LINCOLN PARK PLANNING COMMISSION
SPECIAL MEETING
December 17, 2020 at 6 p.m.

3387 Fort – Plumbing Contractor

Site Plan Review

Applicant	Tracey Yarbrough
Project	Plumbing Contractor
Address	3387 Fort Street, Lincoln Park, MI 48146
Date	December 17, 2020
Request	Site Plan Review
Recommendation	Approval with Conditions

BUILDING SECOND FLOOR PLAN

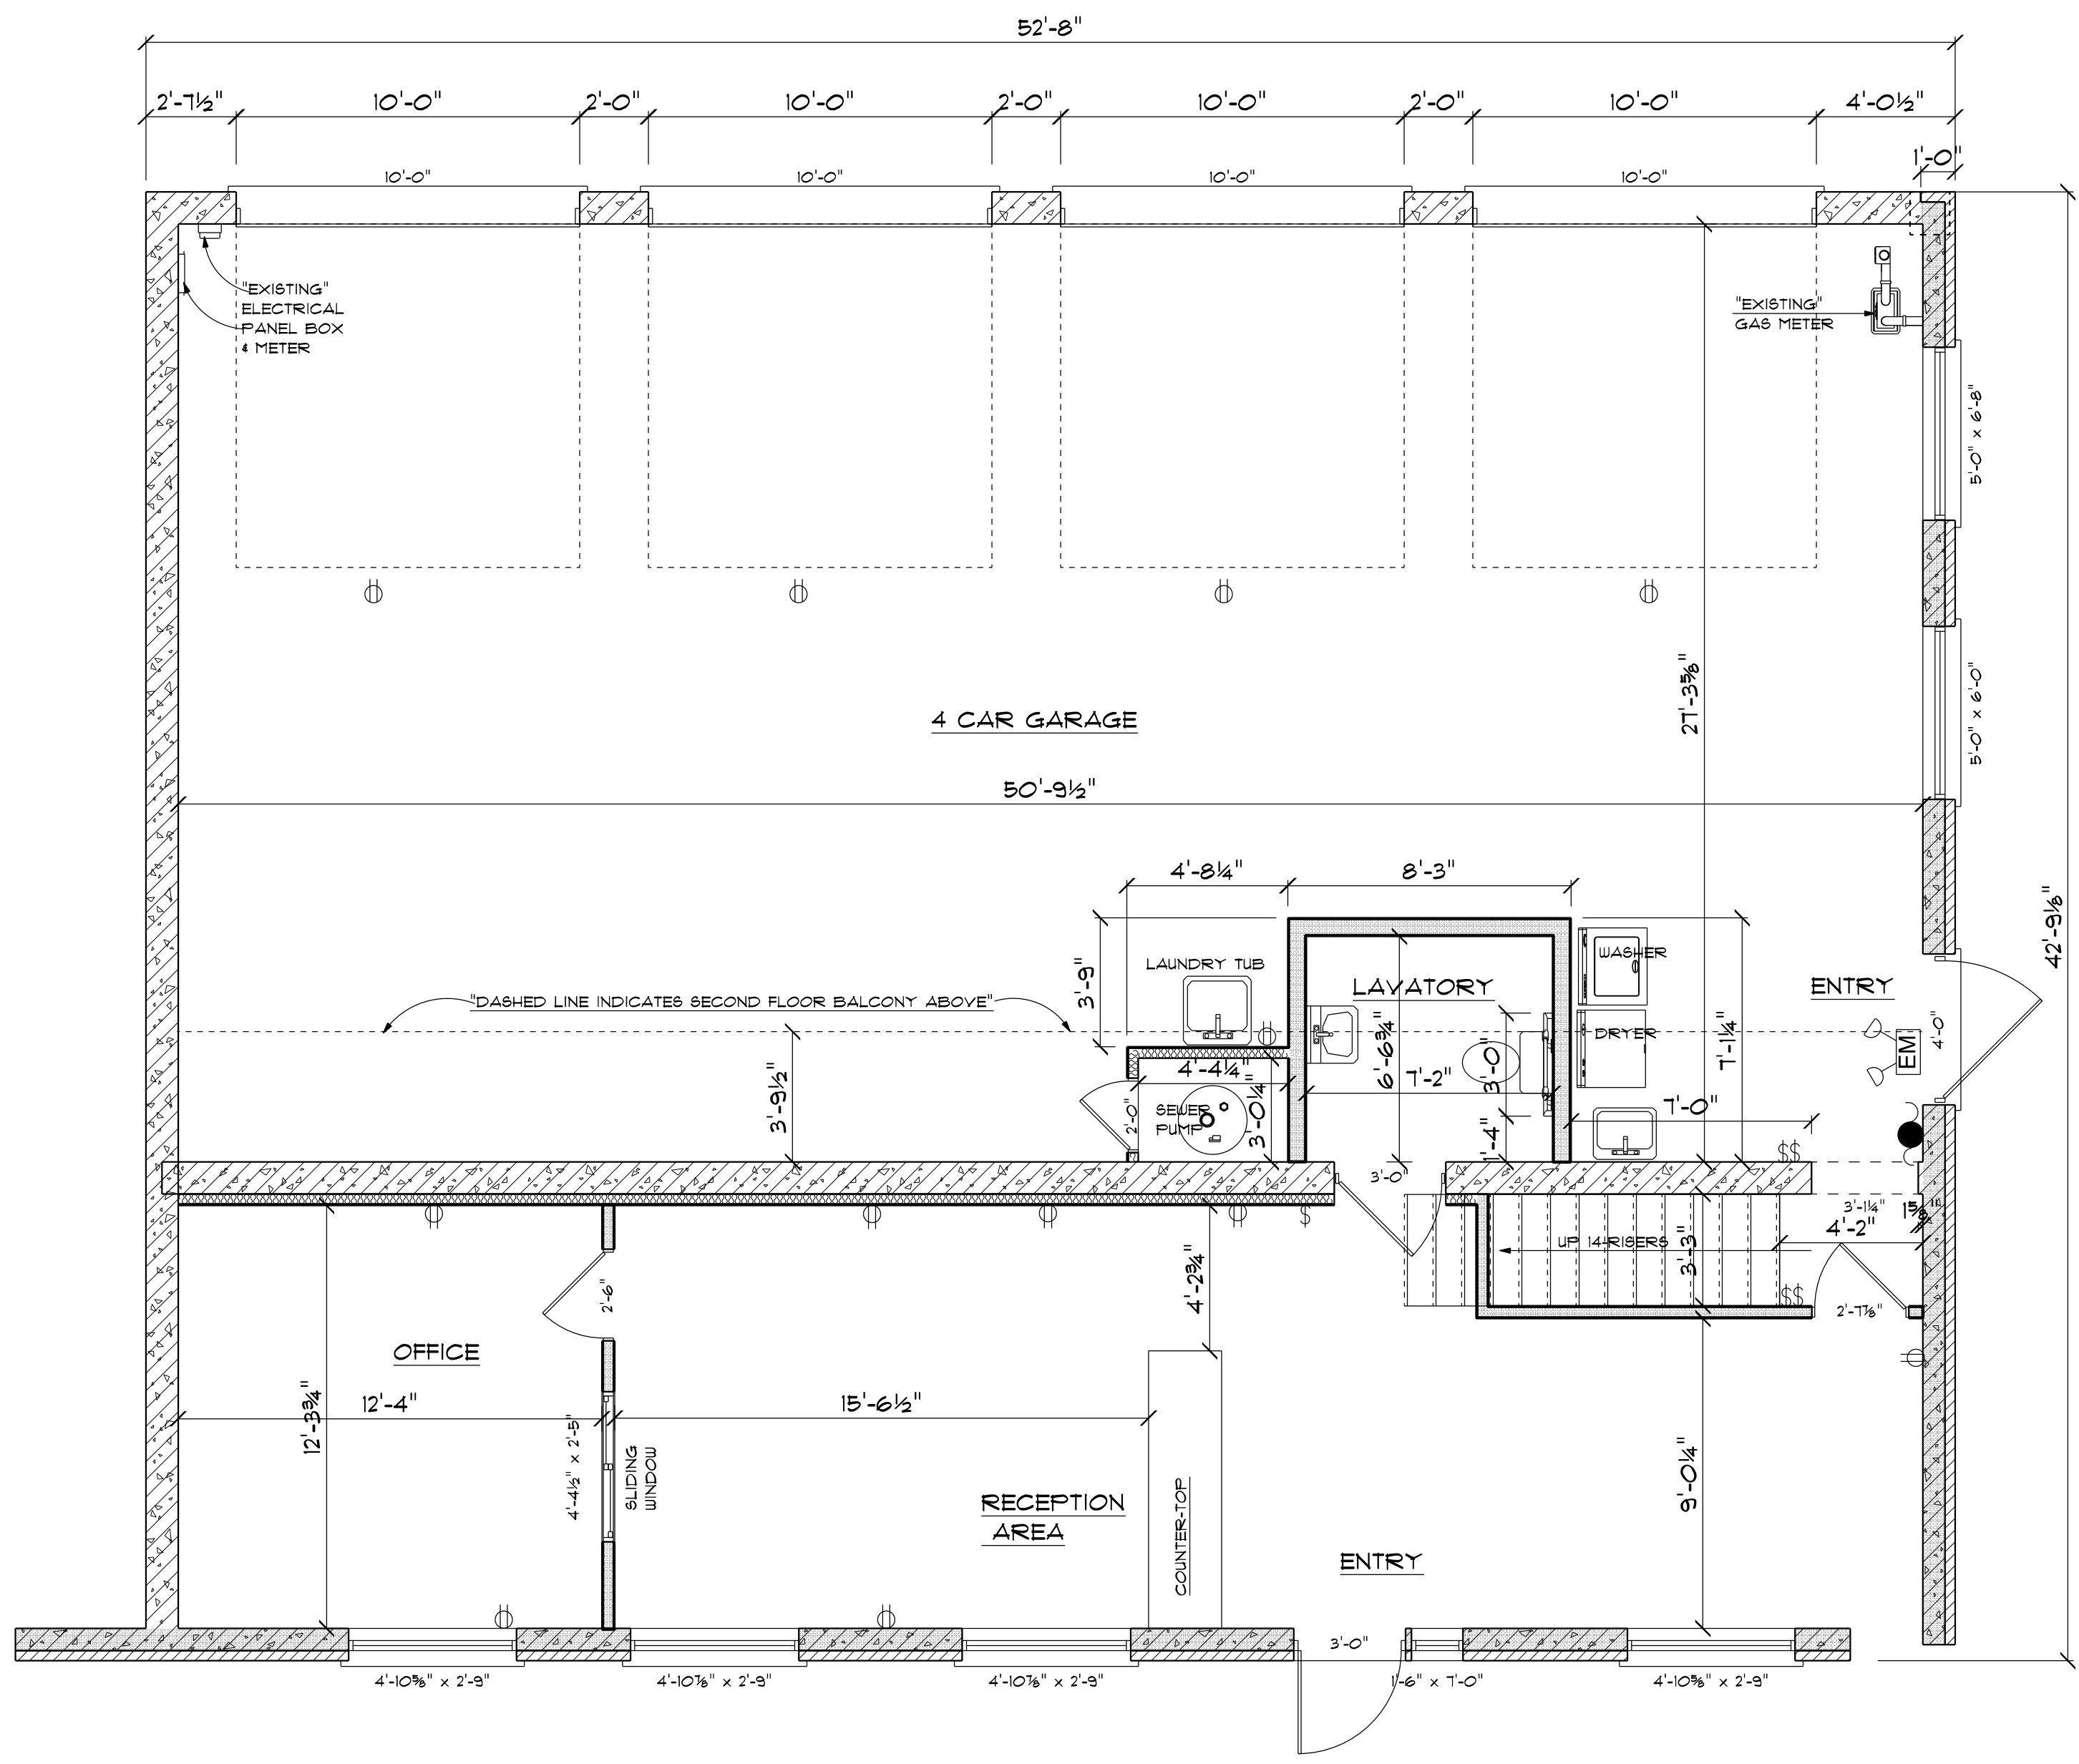
The overall plan looks good. We do want the door swings in the upper balcony storage area to swing in the direction of egress toward the stairs.

- Applicant to secure all appropriate agency reviews as needed.
- The Lincoln Park Fire Department requests that the door in the upper balcony storage area swing in the direction of egress toward the stairs.
- Pavement replacement may require review by Wayne County Drain Commissioner.
